Time to take a stand – the proposed new Ben More hydro track

Benmore East Hydropower Scheme

Address: Benmore Farm Crianlarich Stirling FK20 8QS

Proposal: Construction of a run of river hydropower scheme

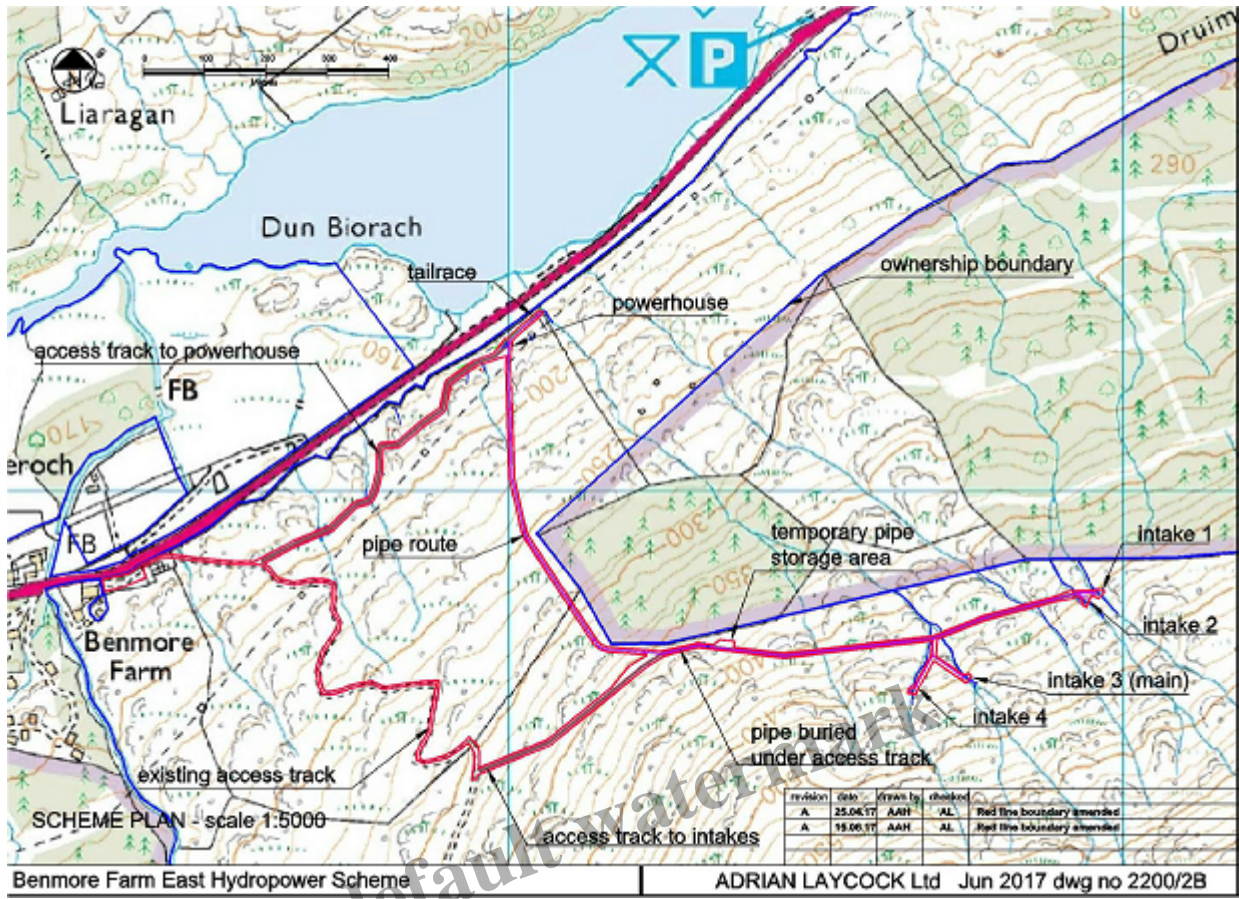
When you approach the intake though the most obvious feature is the metal fencing – contrary to Park guidance on use of natural materials (but is it really necessary?) – and the Lomond blue pipe. Its a shame that the left side of the intake has not been finished like the right had side but it does show, I think, what can be done. Well done somebody!

The recovery of the ground above the pipeline and construction track is not as good as it might have been because vehicles have been driven over land which is far too wet to support them.

Part of the Allt Essan hydro scheme on the north side of Glen Dochart – powerhouse centre

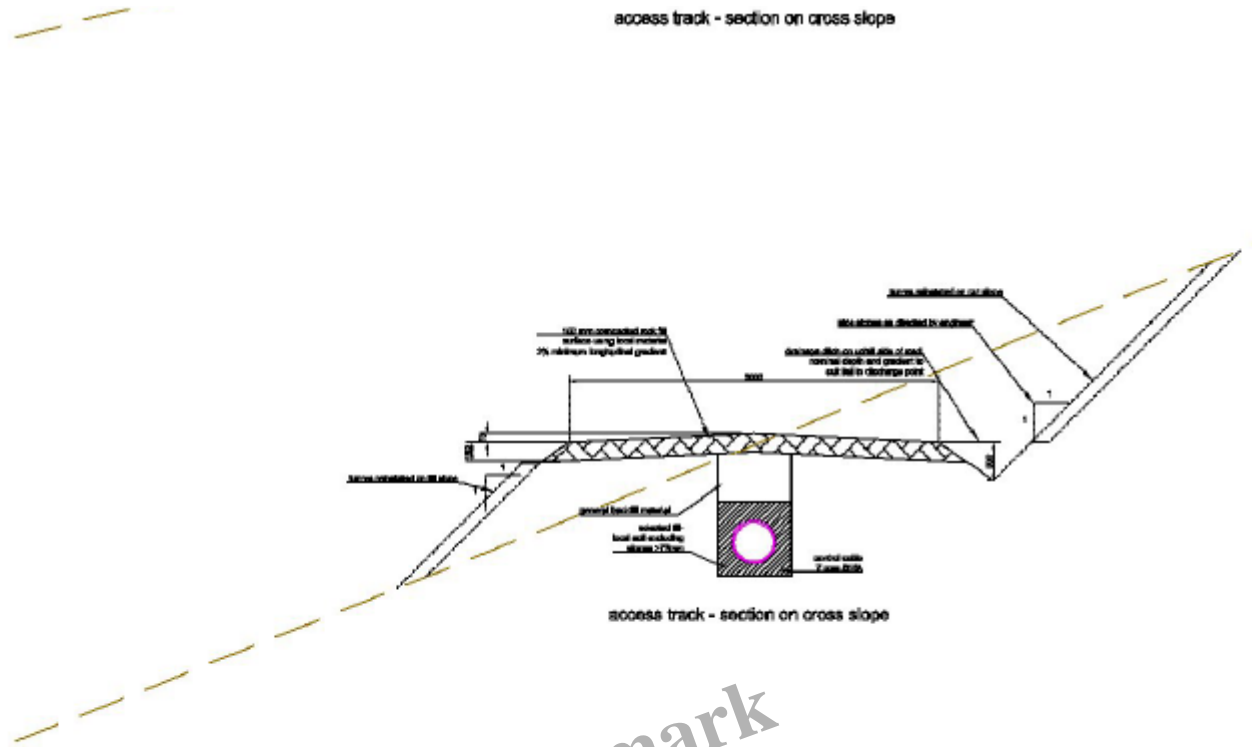
What prompted me to visit the location the scheme was the proposal to retain the new access tracks. Having removed the construction tracks to the intake in the Benmore Burn scheme, I wanted to understand why Benmore Farm were proposing to retain the construction tracks to the new intakes. Part of me reckons that this is because since 2013, when the first scheme was approved, the LLTNPA as Planning Authority have moved from a position of assuming tracks should be removed to allowing them to remain everywhere.

So, if other people are getting away with it, why should Benmore Farm follow best practice? That's why people need to take a stand. The proliferation of hill tracks is destroying the landscape in the National Park – and indeed across Scotland – and those who care about the landscape need to put a stop to this.
